TAL-CO SUPPLEMENTAL INSTRUCTION #75			
JUICE BAR - INCREASED CLEARANCE			
Project Name:	RW TOMLINSON - NEW HEAD OFFICE		
Project Location:	100 CitiGate Drive, Ottawa, Ontario		
ARCH. SI #:	ASK 216	Issued By:	Farah Bano
STRUC. SI #:	N/A	Date Issued:	December 13, 2017
MECH. SI #:	N/A	Revision #:	N/A
ELEC. SI #:	N/A	Revision Date:	N/A

TITLE: JUICE BAR - INCREASED CLEARANCE

PROJECT:
TOMLINSON NEW BUILDING

DATE: 12/12/2017
 SCALE: AS INDICATED
 DRAWN BY: JK
 JOB No: 574-15
 DRAWING No:
ASK-216

DRAWING TITLE:
REF. PARTIAL ENLARGED PLAN 5/A702

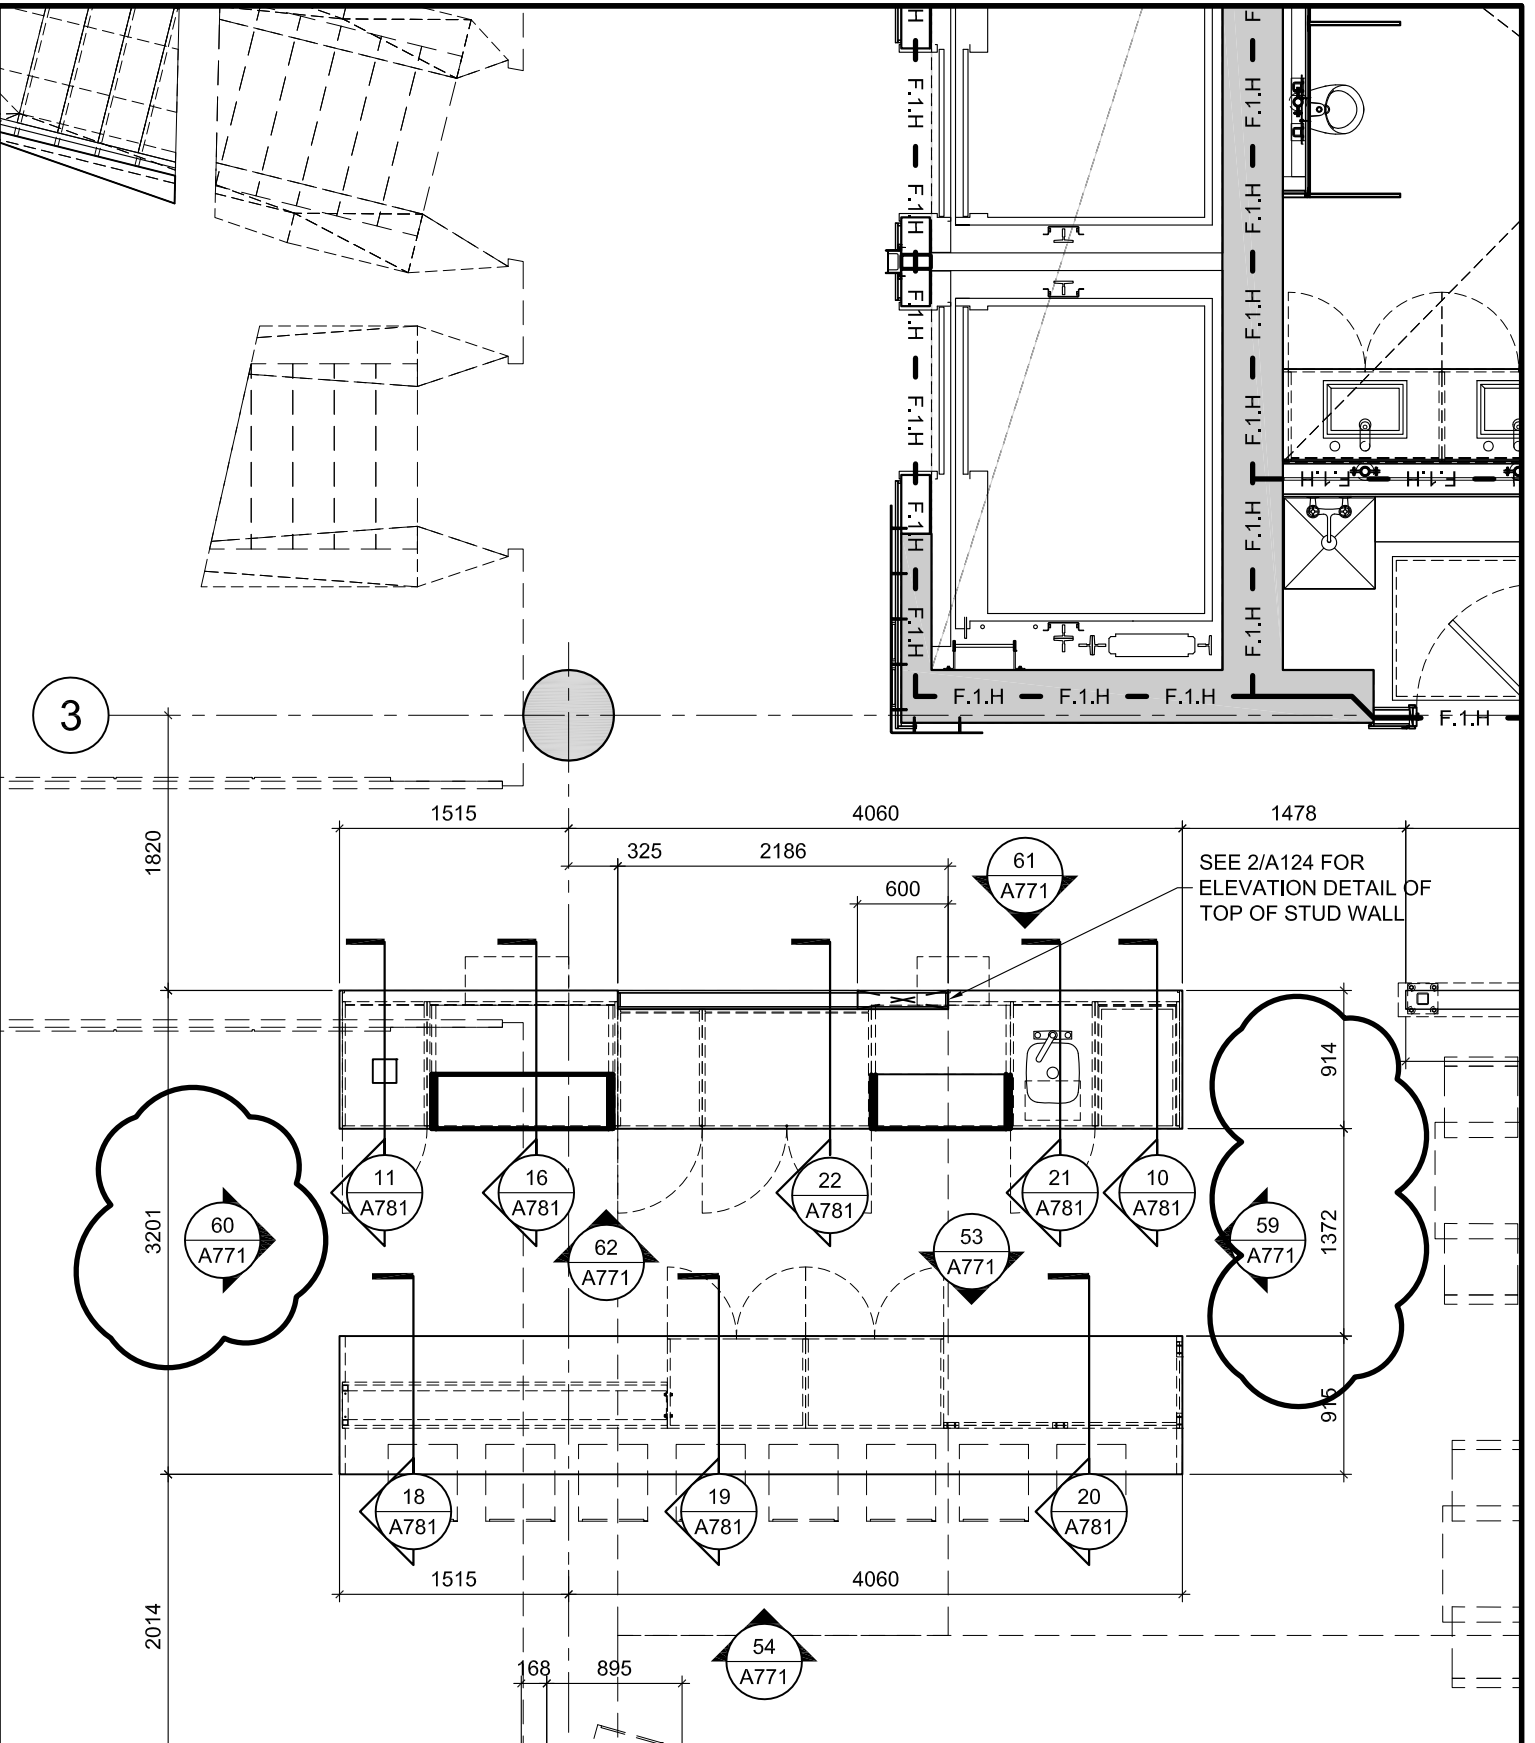
Juice Bar West Cabinet moved further west to increase clearance to 54" (1372mm).

Requested by owner to improve traffic flow through Juice Bar Station.
